Northern States Power Company

MONTICELLO NUCLEAR GENERATING PLANT
Docket No. 50-263 License No. DPR-22

PRAIRIE ISLAND NUCLEAR GENERATING PLANT
Docket Nos. 50-282 License No. DPR-42
50-306 DPR-60

Submittal of Changes to Revision 17 of the
Operational Quality Assurance Program Plan (OQAP)

FIGURE 3.3
CORPORATE ORGANIZATION WITH
NOTE: NUMBERS IN
SECTIONS DESCRIBE

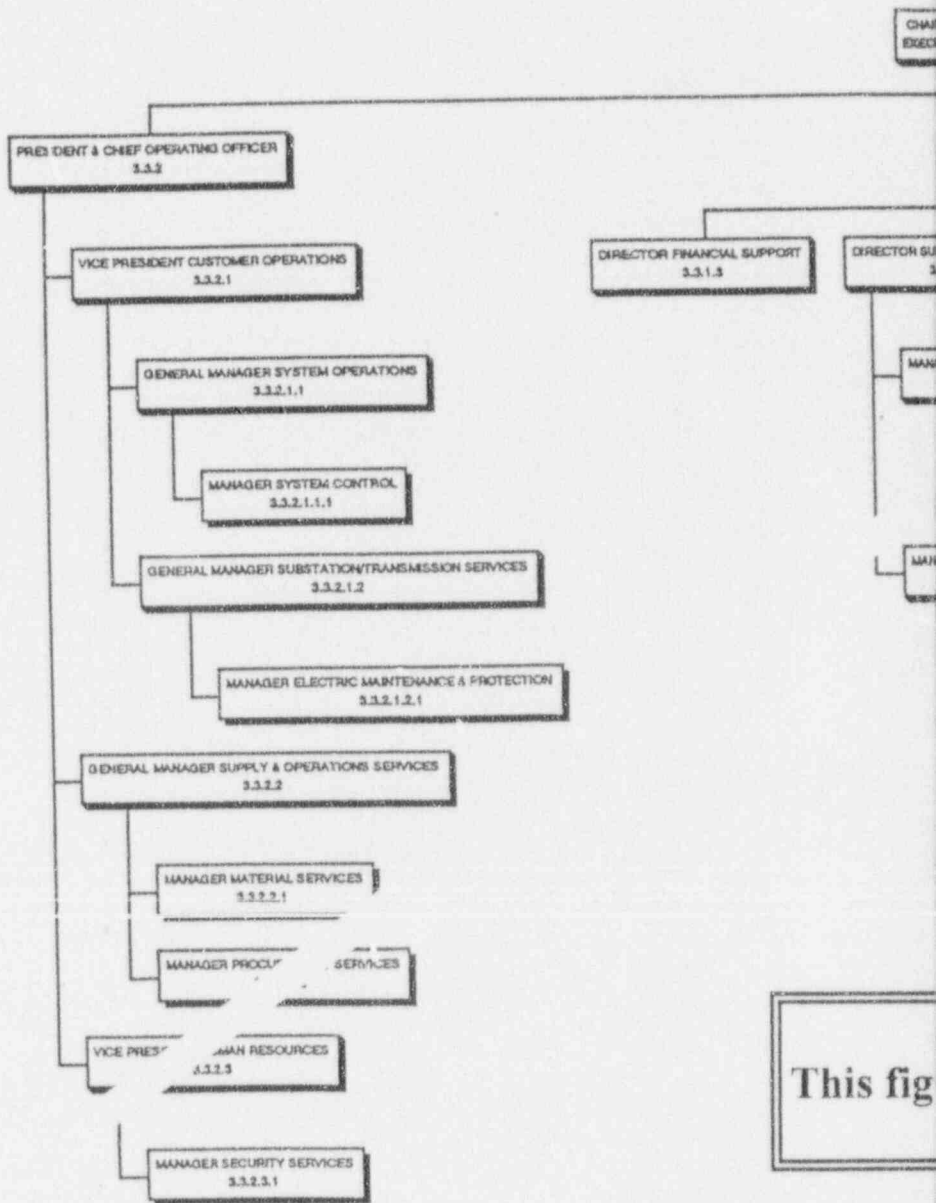
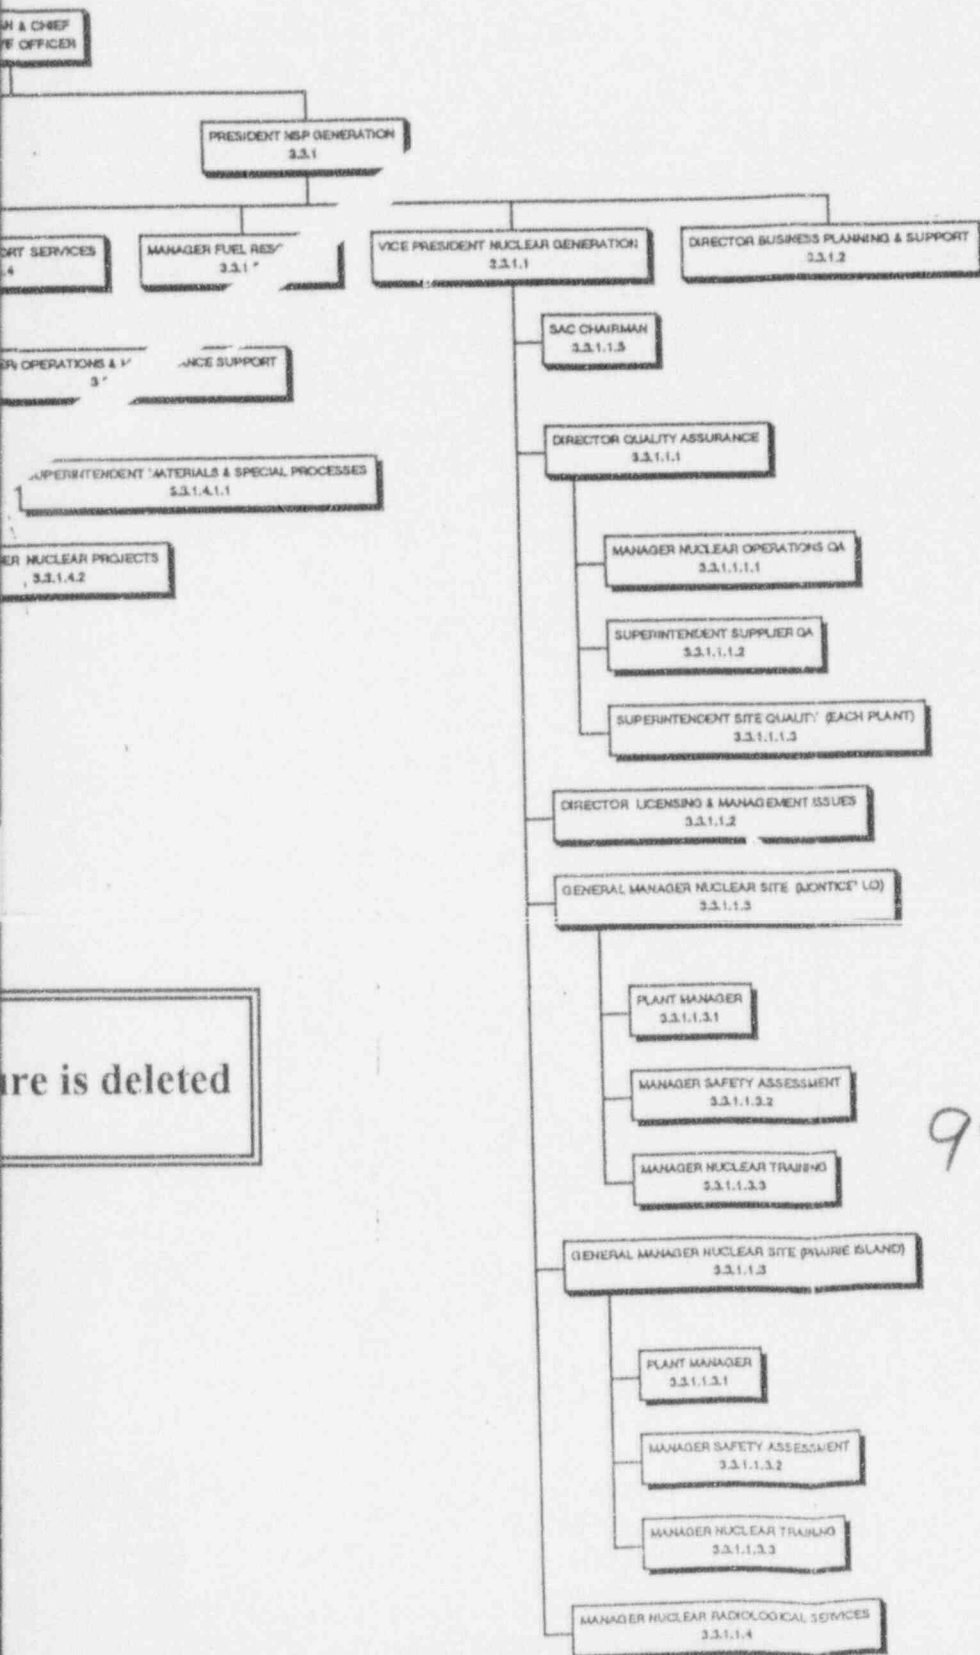
Proposed changes to revision 17 of the Operational Quality Assurance Plan are shown in this attachment. Deletions to the OQAP are shown as strikeouts and the proposed changes are underlined (except for Fig. 1). The page numbers listed below apply to the page numbers in revision 17 of the OQAP.

are is deleted

This change proposes to incorporate in Revision 18 of the Operational Quality Assurance Plan (OQAP) a simplified representation of the Northern States Power (NSP) organization and the functions performed by the organization. This change would replace current sections 3.2, *Quality Organization Summary*, and 3.3, *Corporate Organization with Operational Quality Assurance Program Responsibilities*, and the current organization chart (Figure 1) with a revised organization chart (as the new Figure 1) showing the primary management positions and their functional responsibilities. Attachment 1 shows the proposed changes in markup form.

1 Quality Assurance Responsibilities

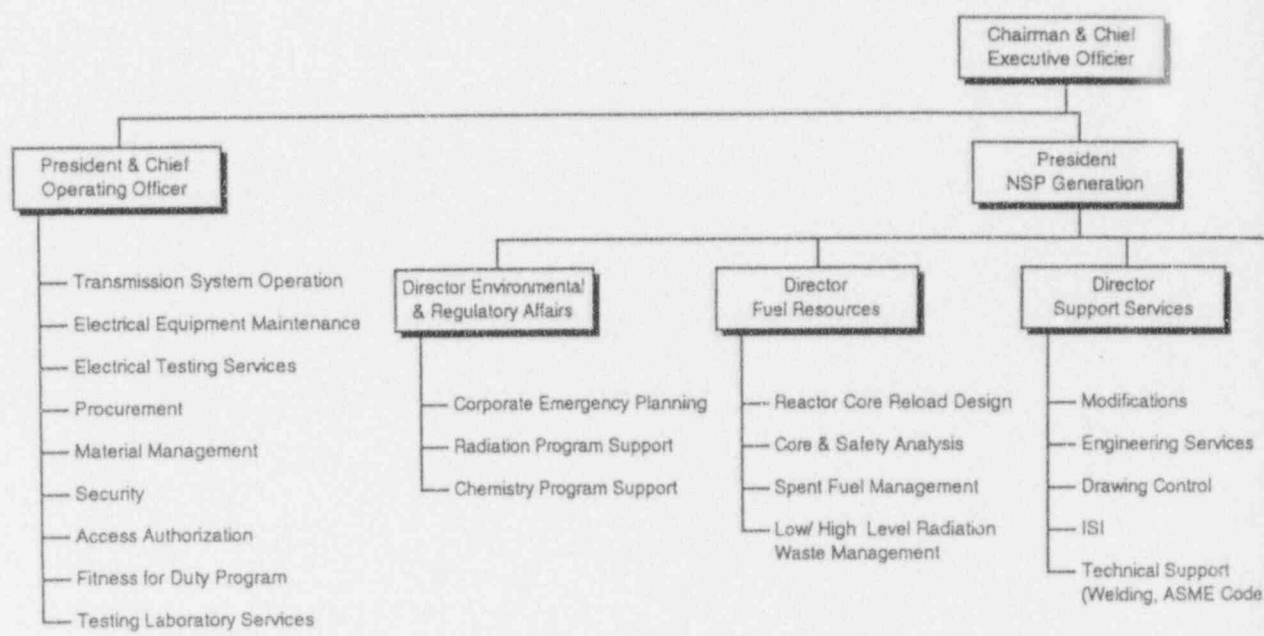
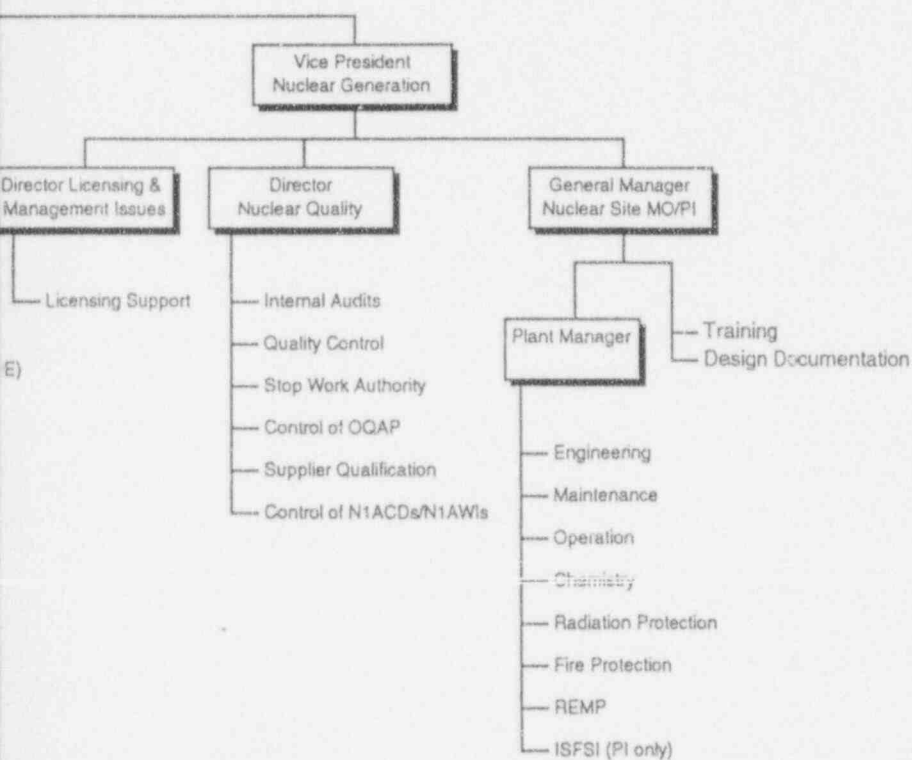
NOTE: The organization displayed is for revision 18 of the OQAP, not the organization of revision 17. This note will not appear on the original figure included in OQAP, revision 18.

Figure 1, NSP Organization with Operational Responsibilities, presents an organizational chart of NSP showing a summary of functional responsibilities.
